FURNISHING MISCELLANEOUS ITEMS INVOLVED IN NRC REVIEW OF APPLICANT'S APPL FOR AN OPERATING LIC FOR SUBJECT FACILITY, CONSISTING OF INFO RE SAFETY RELATED CABLES, SPLICE, CONNECTOR AND TERMINAL BLOCK, ET-AL.. W/ATT DRAWING.

PLANT NAME: DIABLO CANYON - UNIT 1
DIABLO CANYON - UNIT 2

Re: Docket No. 50-275-OL
Docket No. 50-323-OL
Diablo Canyon Units 1 & 2

FIGURE 1

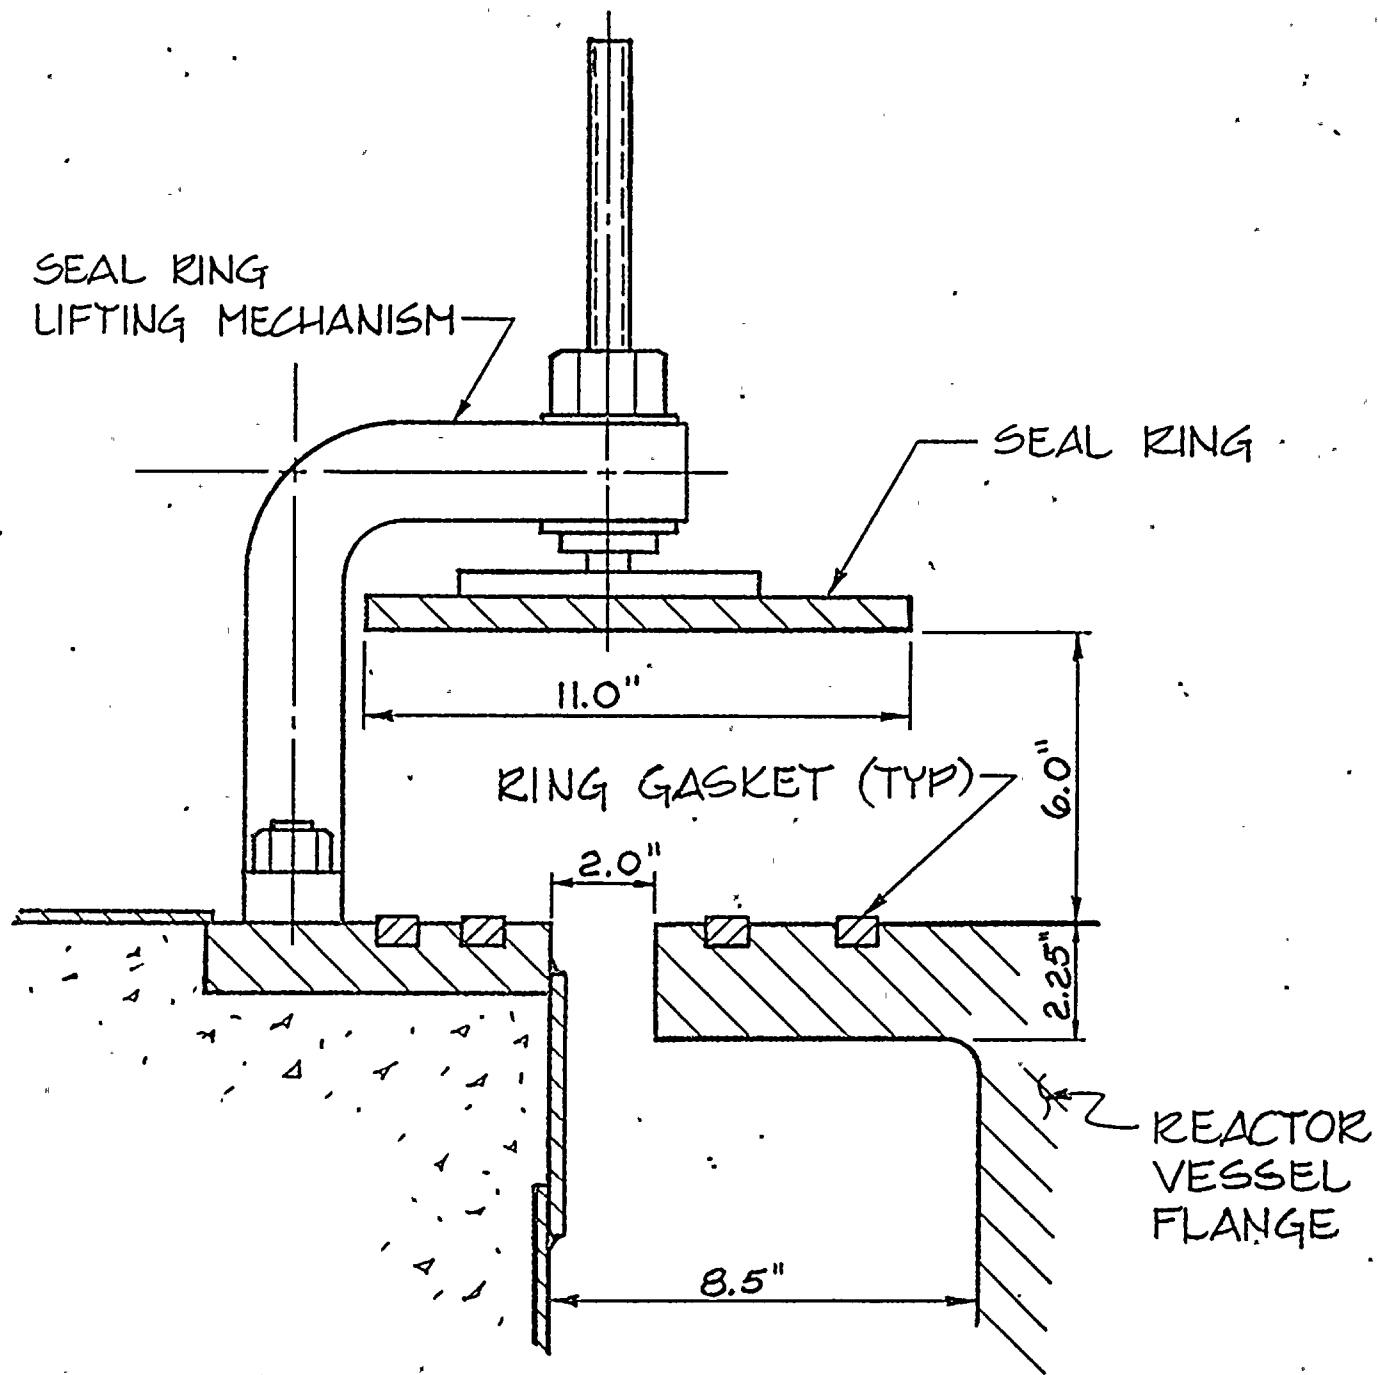
The following information is provided in response to the letter of February 2, 1978 to PWR licensees from Mr. Victor Stello, Jr., regarding the reactor cavity annulus seal ring.

The Diablo Canyon reactor cavity annulus seal ring is left in a raised position during normal operation. Figure 1 is a representative cross-section of the seal ring in this position. Biological shielding material is not employed in the reactor cavity annulus.

The seal ring has been evaluated for the effects of a loss of coolant (LOCA) pipe break inside the reactor vessel cavity. Determination of the loading on the seal ring assembly was based on the peak calculated LOCA pressurization (115 psig)¹ of the uppermost compartments of the reactor cavity. A maximum local load of 8,800 pounds was calculated for the region immediately above the broken pipe. The most highly stressed member resulting from this maximum load is above the material yield stress, but is below the ultimate strength of the material. Should this member yield, load redistribution to adjacent members would be expected. We therefore conclude that the reactor cavity seal ring will not become a missile as a result of a pipe rupture within the reactor vessel cavity.
